Rear Elevation

For:		Job:	49 Redhoods Way West, Letchworth		
		Title:	Proposed Rear Elevation		
Mr. N. Winter.		Scale:	1:50 @ A3		Date: Nov 2024
		Dwg No:	NWM / 2023 / P5		Rev: A

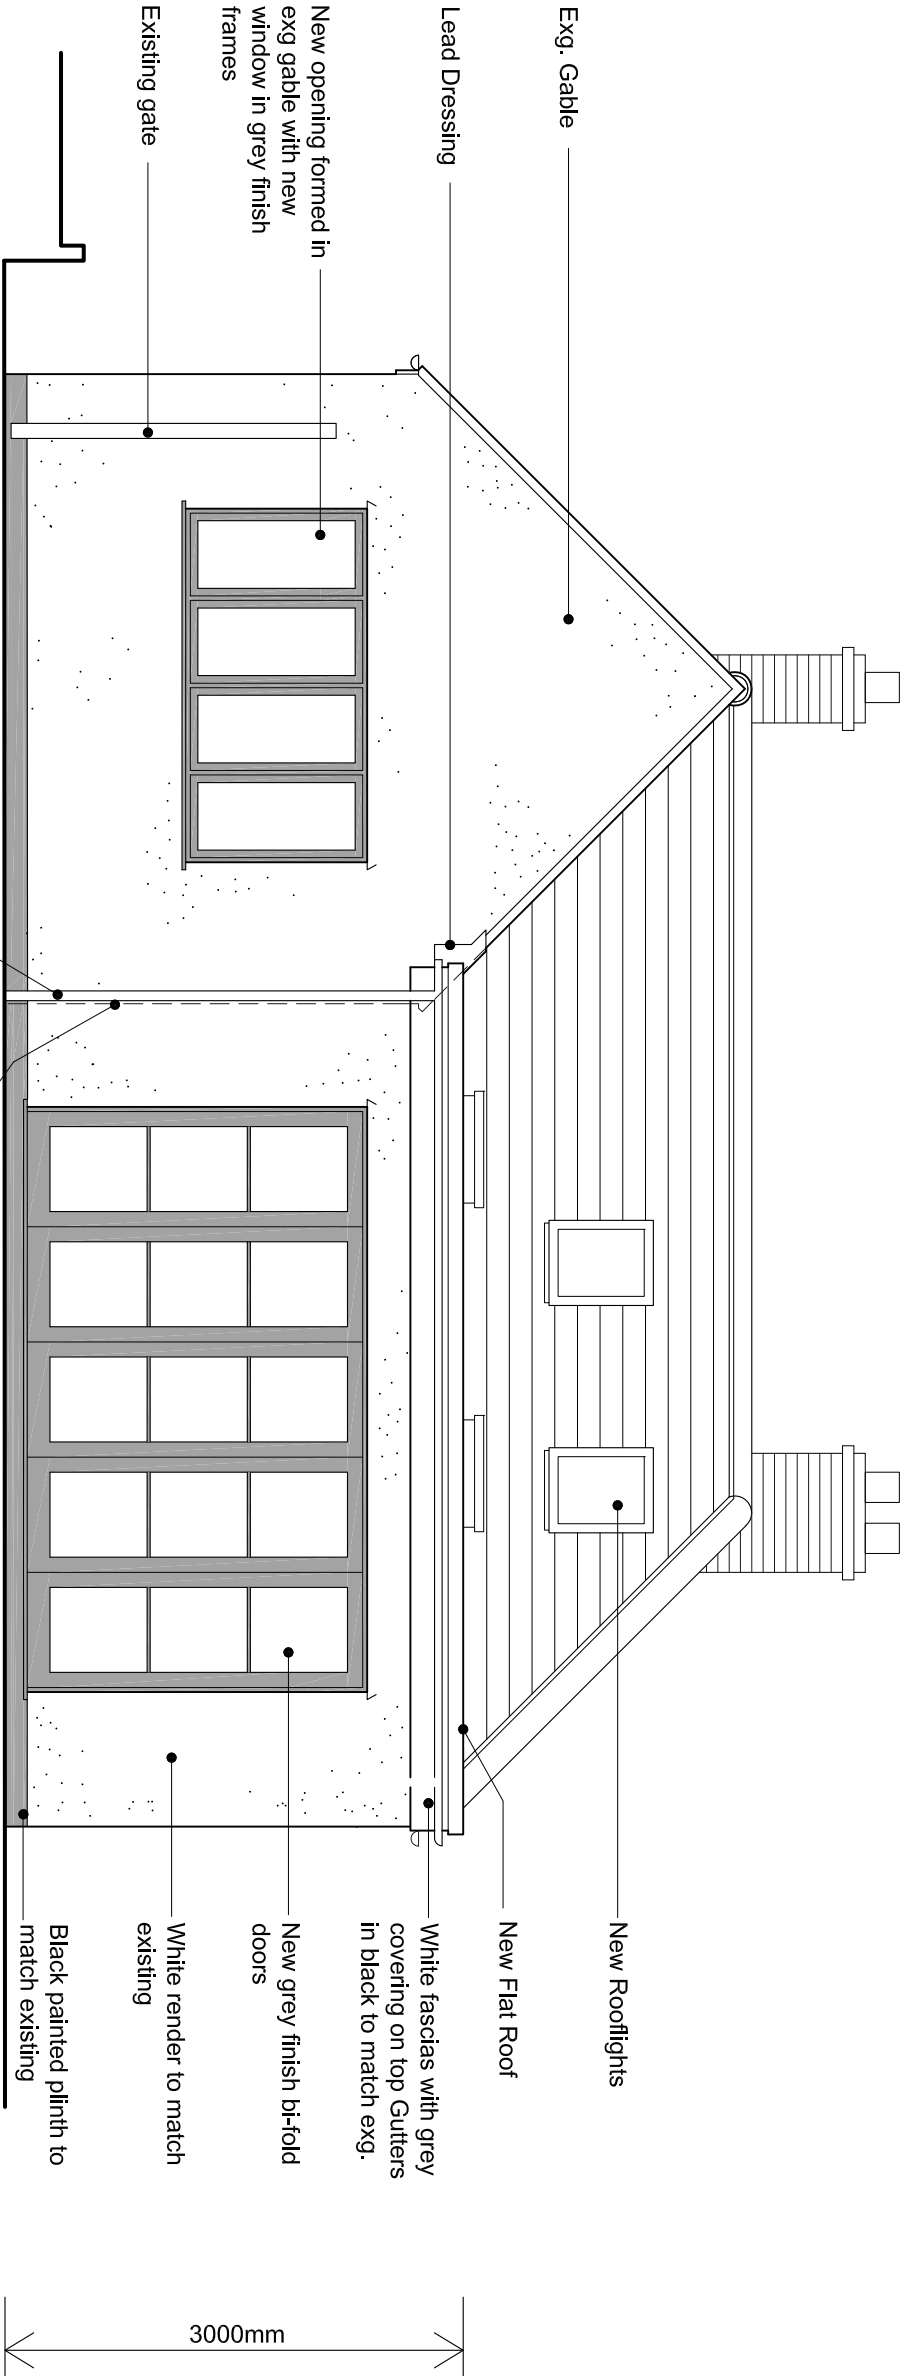
REVISIONS: Nov. 2024: Drawing revised to show existing (pitched roof) rear extension retained with proposed extension reduced in size to fill in the North East corner.
